HISTORIC AND DESIGN REVIEW COMMISSION

June 07, 2017

HDRC CASE NO: 2017-266
ADDRESS: 458 FURR DR
LEGAL DESCRIPTION: NCB 6696 BLK 5 LOT 22 W 25 FT OF 23 E 25 FT OF 21
ZONING: R-6 H
CITY COUNCIL DIST.: 7
DISTRICT: Monticello Park Historic District
APPLICANT: David and Lydia Lerma
OWNER: David and Lydia Lerma
TYPE OF WORK: Window replacement
REQUEST:

WEST

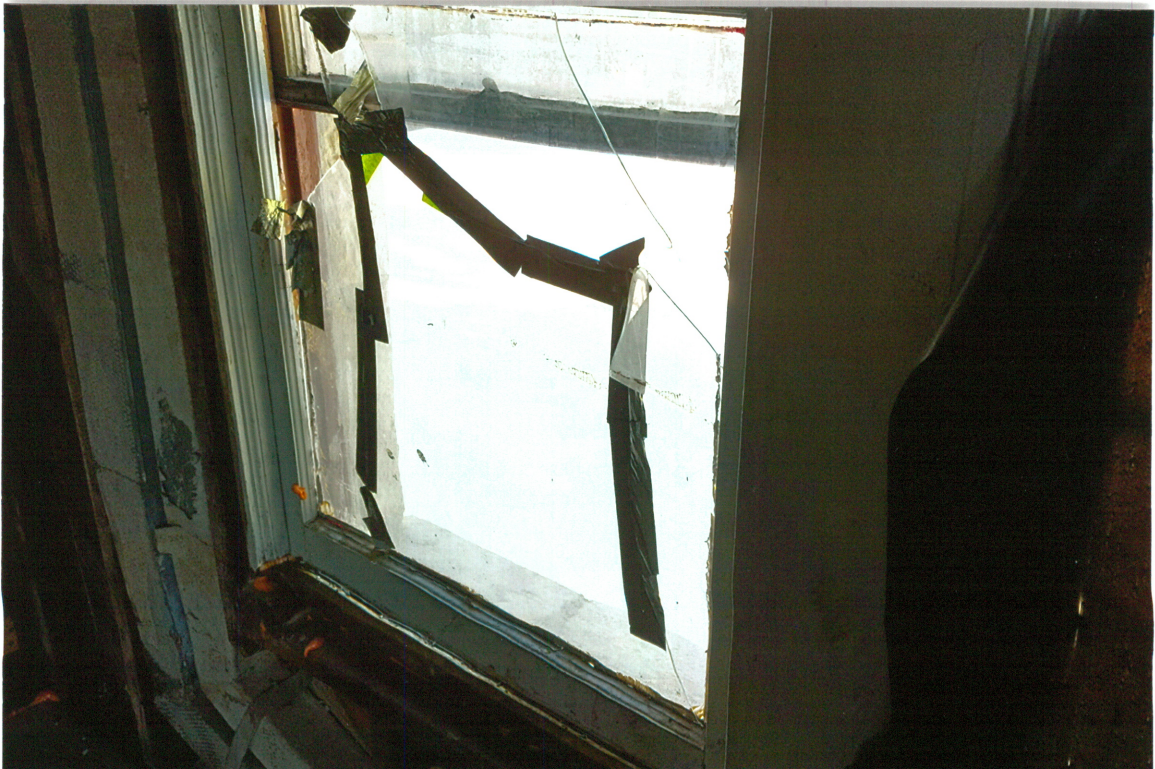
- d. **DIVIDED LITE WINDOWS** – Staff conducted a site visit on May 26, 2017. All three of the tri-panel windows feature vertical side panels with 4 true divided lites. They are original to the home. On all three of the assemblies, the lowest lite, adjacent to the sill, has deteriorated severely. Several lower wood rails have disintegrated due to rot, or are partially or completely separated from the rest of the assembly. According to the Guidelines for Exterior Maintenance and Alterations 6.B.iv., windows should only be replaced if approximately 50% or more of the assembly is deteriorated beyond repair. While the lower rails and stiles of the side panels are severely deteriorated, these portions constitute approximately 20% of each panel, and less than 10% of the entire tri-panel assembly. Replacement wood pieces can be fabricated and installed to match the existing configuration. Additionally, the one set of existing side hinge windows are in good condition and can be repaired. These particular windows are extremely unique and characteristic of the home and should not be replaced. Staff finds the proposal inconsistent with the guidelines.

- e. **NON-ORIGINAL SINGLE PANES** – Two of the three sets of tri-panel wood windows have been altered over time, and their central panel, which historically featured two operable side hinge windows that opened to the outside, have been removed and replaced with a single pane panel, which appears to be plexiglass or a similar quality. Staff finds the proposal to install a new double pane glass panel acceptable given the non-historic nature of the existing material.

- f. **SET OF SIDE HINGE WINDOWS** – One of the sets of the tri-panel wood windows has original two hinged panels in the central bay that open to the outside and contain true divided lites. These windows are located on the east (side) façade of the home. The applicant has proposed to replace these operable hinged windows with a new double glass panel. According to the Guidelines for Exterior Maintenance and Alterations 6.B.iv., windows should only be replaced if approximately 50% or more of the assembly is deteriorated beyond repair. These operable windows are in reparable condition and are character defining elements of the home and should be retained. Staff finds the proposal inconsistent with the Guidelines.

Item 2, Staff does not recommend the replacement of the three windows with divided lites with fixed glass panels based on findings a through d.

Item 3, Staff recommends approval of the non-original single pane panel replacement based on finding e.

Item 4, Staff does not recommend approval of the replacement of the original side hinge operable windows based on finding f.

↑
SOUTH - SUNDECK
REAR

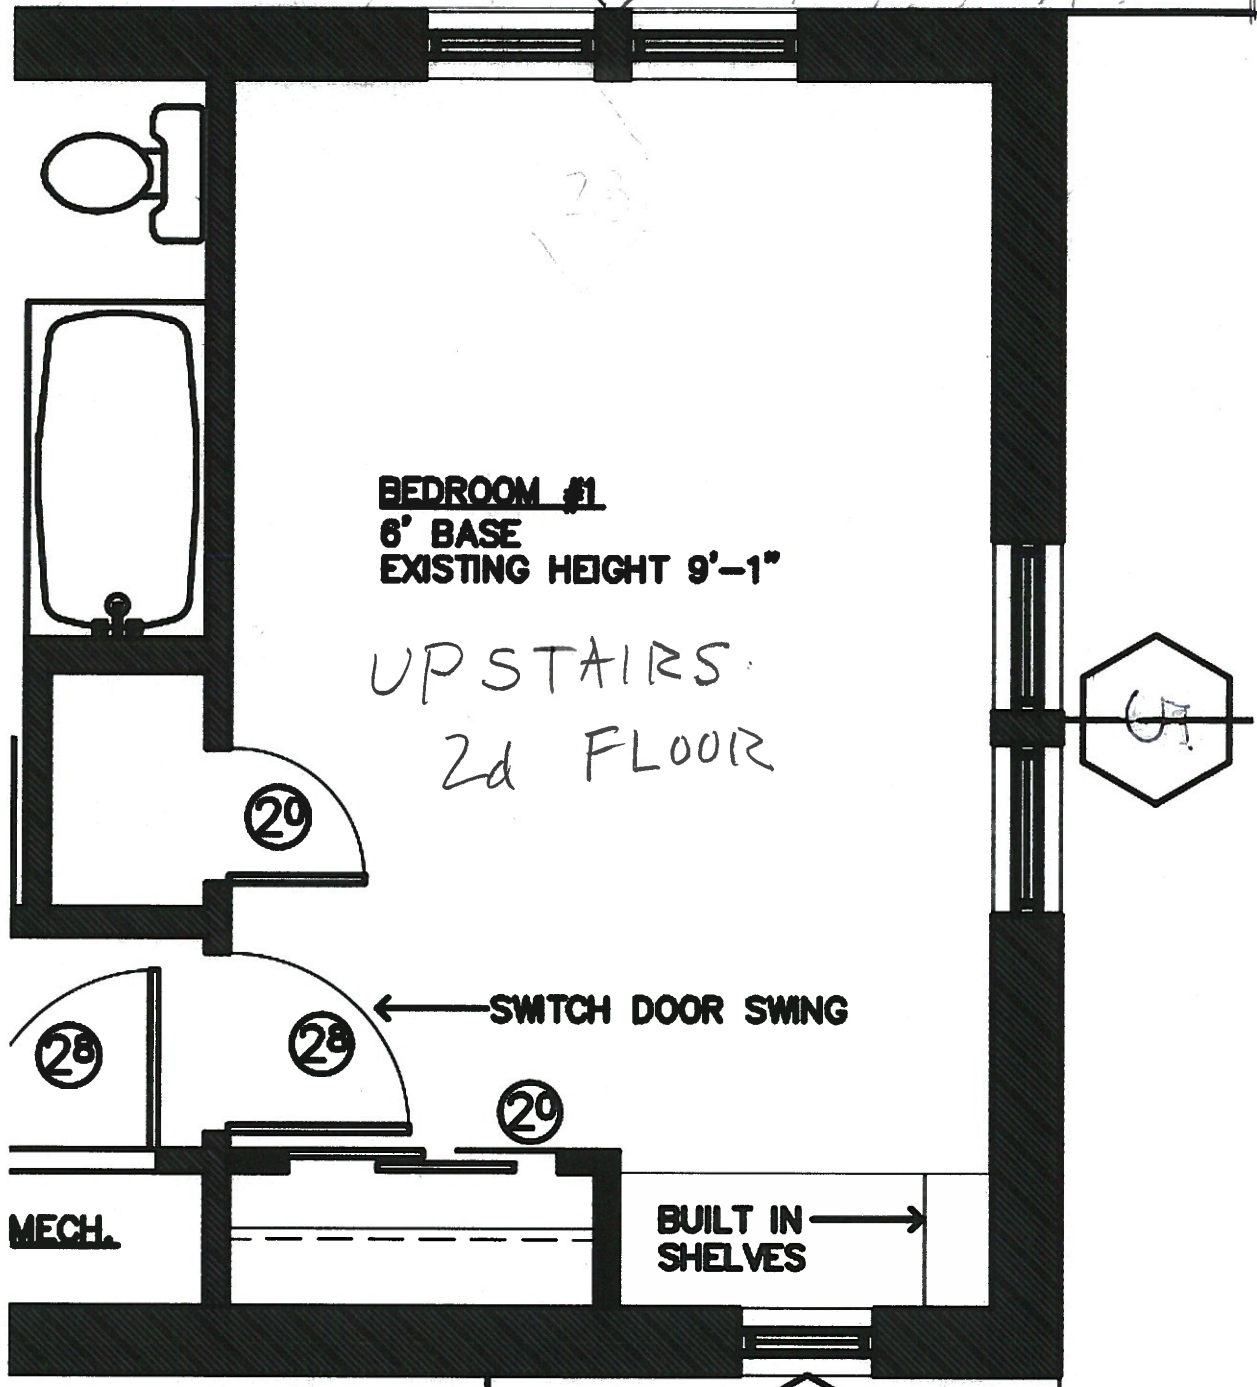
- c. **ONE OVER ONE WINDOWS** – Staff conducted a site visit on May 26, 2017. The four wood one over one windows located on the second floor are not presently operable. They do not have functioning weights, have expanded into their pockets due to exposure to humidity, and a few contain broken glass panes. However, the extant assembly is in good condition. None of the windows exhibit joint separation, interior rot, or checking of the wood. They are of high quality material and craftsmanship and can be restored. According to the Guidelines for Exterior Maintenance and Alterations 6.B.iv., windows should only be replaced if approximately 50% or more of the assembly is deteriorated beyond repair. Staff finds the proposal to replace the three windows with true divided lites with new one over one wood windows inconsistent with the guidelines.

Item 1, Staff does not recommends approval of the replacement of the four one over one windows based on findings a through d.
